Richmond Hill Campus

Addendum to Stage 3 Report

Document no. 1399-INT-ZZ-ZZ-RP-S-0004

This report is an addendum to the Stage 3 report submitted as part of the Listed Building Consent application. It addresses the items raised in Stand Consulting Engineers' letter dated 25 April 2024.

Existing condition

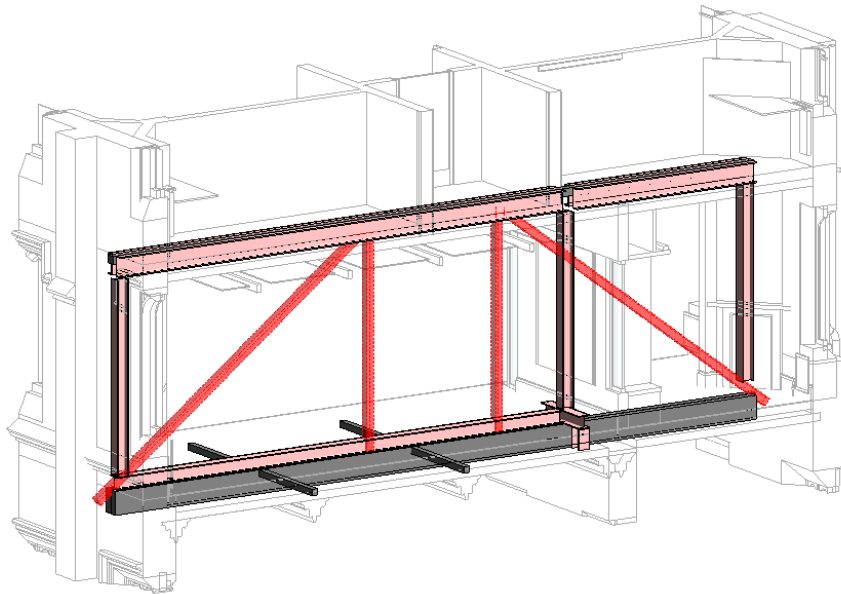
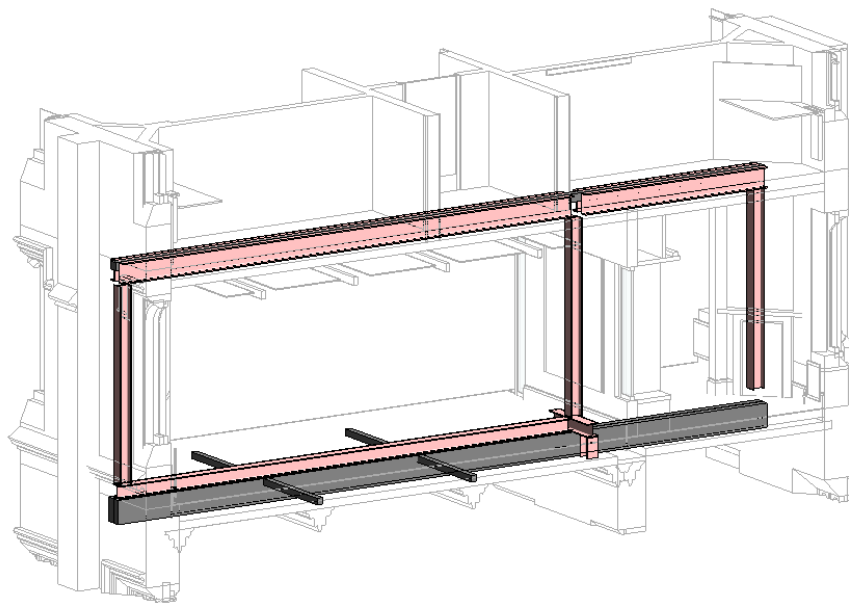
Opening up works to confirm structural elements has been undertaken since the Stage 3 report was written. This has revealed that the partitions to the 2nd floor of the main building are acting as trusses.

A design has been developed to allow the removal of the stud walls and the struts within. This requires the propping of the existing floors. Once propped the struts are to be removed and new steel installed.

To the 2nd floor the strengthening is to be installed from above the existing timber beams. At 3rd floor the strengthening is simply installed to the underside of the floors.

Section through proposed moment frames with propping indicated

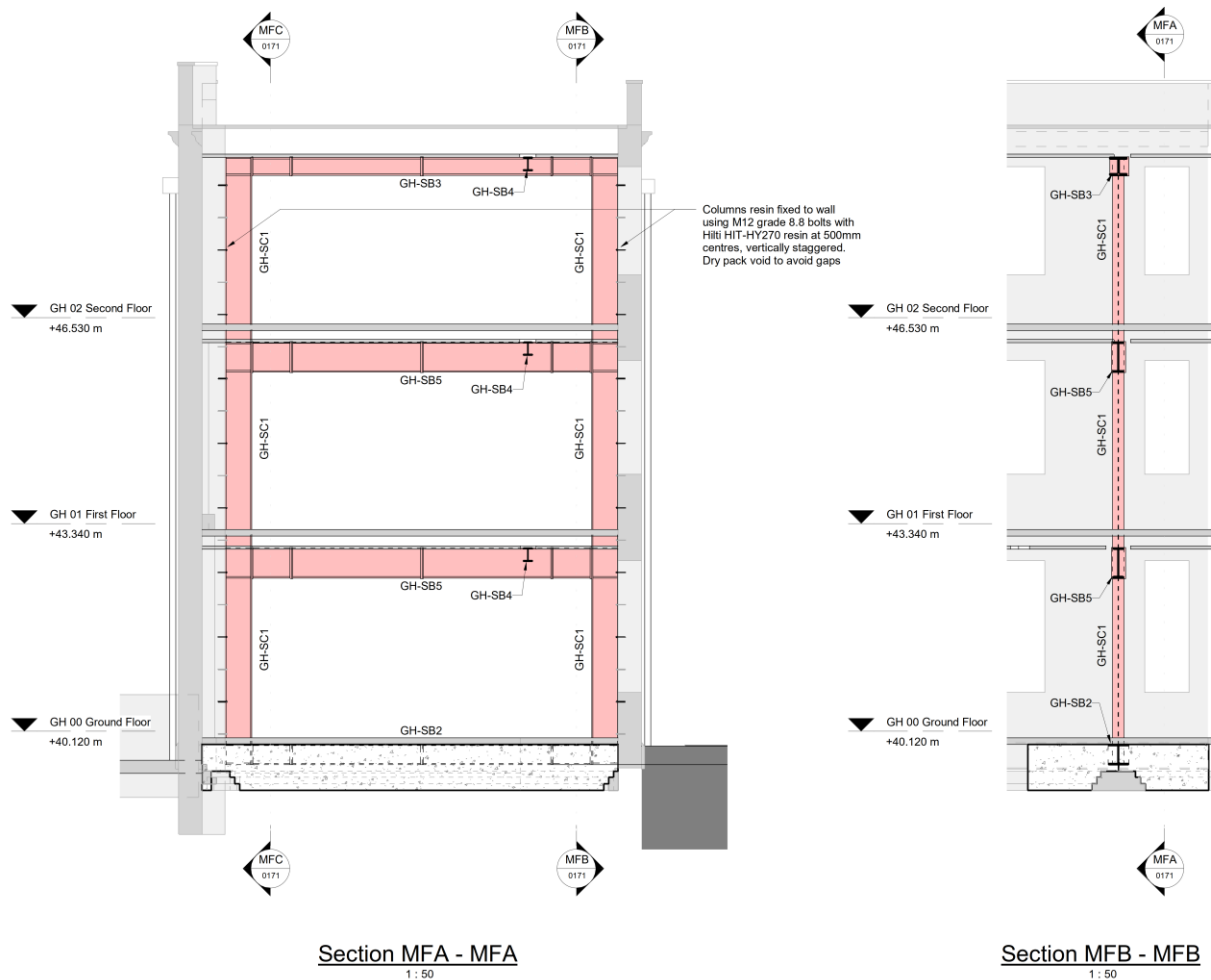
Whilst parts of George House do pre-date the main building, it is noted that the proposed alterations and wall removals are within the later development. The exact date of the works is unknown. The Heritage Significance Appraisal states:

The rib and pot floors are not original and as such not an early example of this form of construction. They are therefore not considered to be of higher significance than other fabric.

Once the slabs are propped and supported the walls can be removed and the new frames installed. Openings for columns to pass through floors are to be minimised to reduce the amount of infill required. Once dry packed the temporary propping can be removed and the load transfer is complete.

The slab will act as a diaphragm and temporarily distribute stability forces into the remaining walls. The moment frame restores the original load paths once the works are complete.

The size of the opening for the columns is to be agreed with the contractor. It is proposed these are kept as small as possible so that a new infill stitch can be cast to transfer load in the final condition.
